May 19, 2025

ADDENDUM No. 2 2025 ROAD IMPROVEMENT PROGRAM

CITY OF OREGON
DEPARTMENT OF PUBLIC SERVICE

Addendum #2 (Issued 5/19/25)

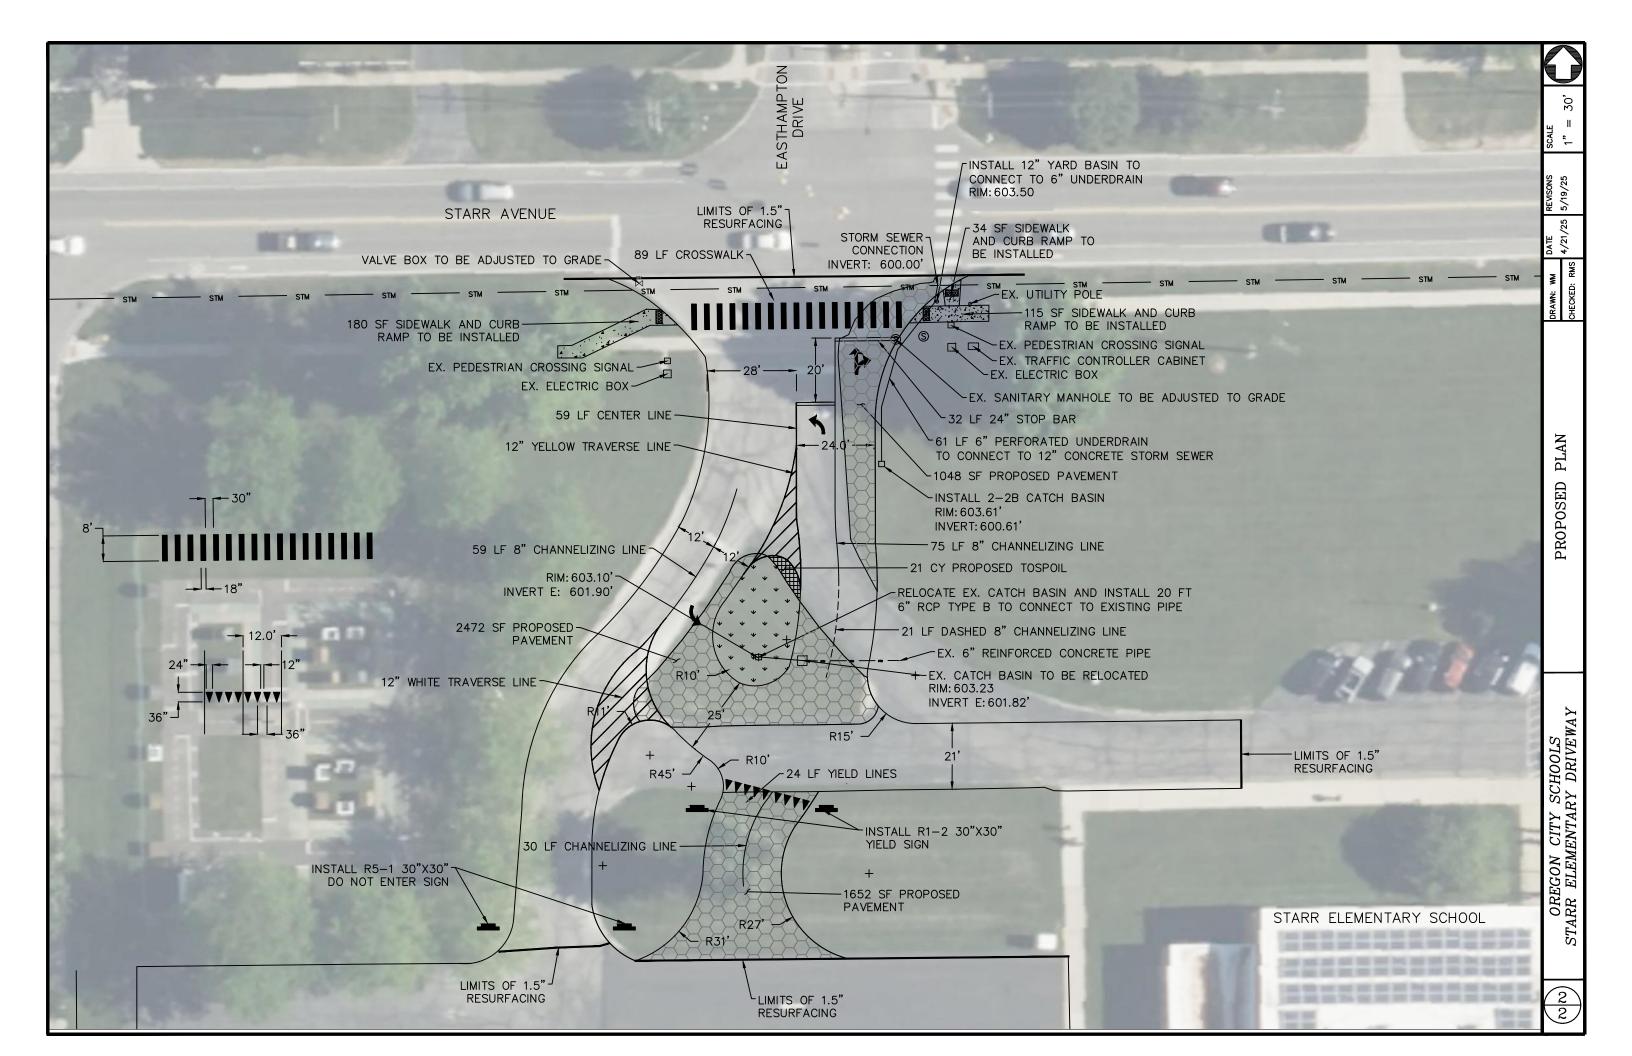
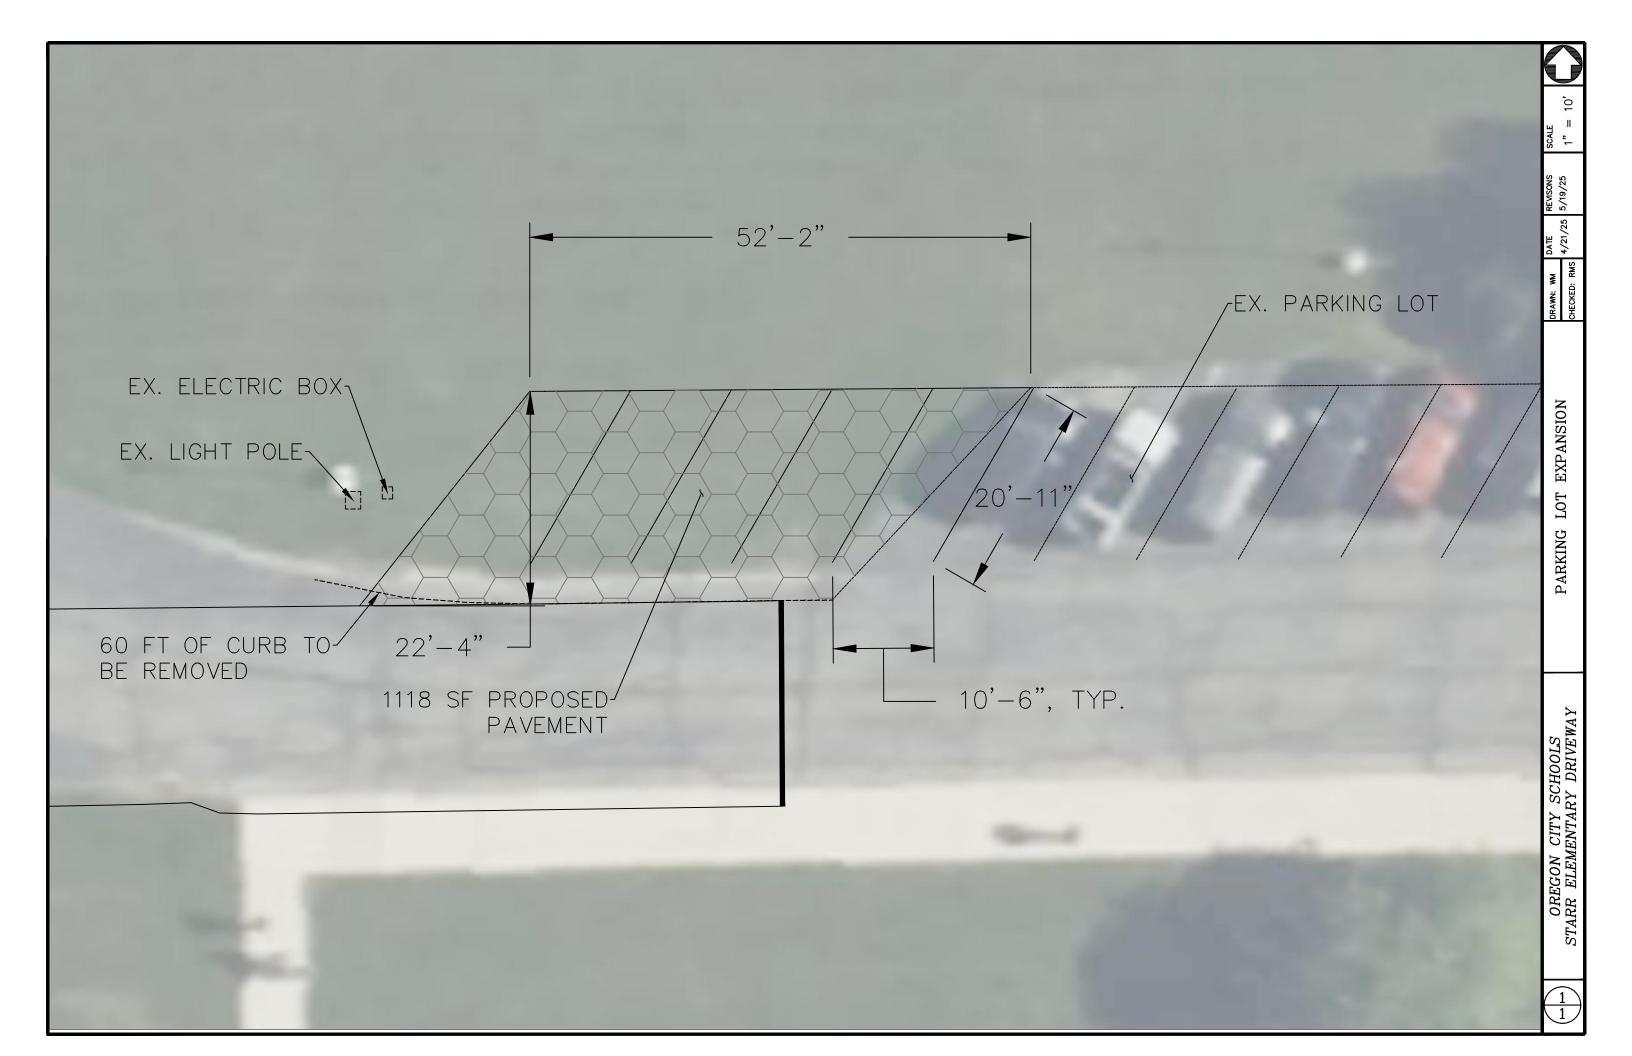
- Project #5 Is the contractor required to remove any excess topsoil from stockpile off site?
 Yes, the contractor is responsible for removing all excess material from the site, including any surplus topsoil from stockpiles.
- Project #5 Regarding the 'Spoil Material' note on plan sheet 7, it says; The City of Oregon will
 provide a disposal site as shown in the Schematic Plan for all spoils resulting from this project.
 Looking at the Schematic Site Plan on plan sheet 2, there doesn't appear to be any disposal
 site shown. Please Clarify. Also, can concrete from job be buried within the disposal site?
 Does the stockpile need to be seeded and mulch when the project is completed?

Project #5 - Under ref #29 the description for the 6" Conduit, TY F it says; 12" wide by 8" deep.
 On sheet 23 the Catch basin at sta 232+87.85, 54.1',rt the invert shows a depth of the 6" cond., TY F west at +/-3' deep. Is the description 12" wide by 8" deep suppose to be for the aggregate drains? Please clarify.

Project #5 – On sheet 18, the plan profile from sta 212+00 to 213+40 shows 140' -6" shallow pipe UD. On sheet 13 for that area the sub summary shows the pipe as 6" unclassified. Please clarify.

The note on Sheet 7 referencing a City-provided disposal site was carried over in error from a previous phase of the bikeway project and does not apply to this project. This note has been removed on the revised sheet 7. All spoil materials generated from this project, including concrete, must be removed from the site and properly disposed of by the contractor.

Additionally, the 200-foot contingency quantity **for 6" Unclassified Pipe Underdrains with Geotextile** (*formerly Pay Item 27*) has been removed by deleting the corresponding note on Sheet 7.

All underdrain pipes for this project shall be **6" Shallow Pipe Underdrains** installed 18" below the bottom of subgrade. Geotextile fabric will not be required for these underdrains. The pay reference for **6" Unclassified Pipe Underdrains with Geotextile** has been removed from the bid form.

Note Deleted

Note Deleted
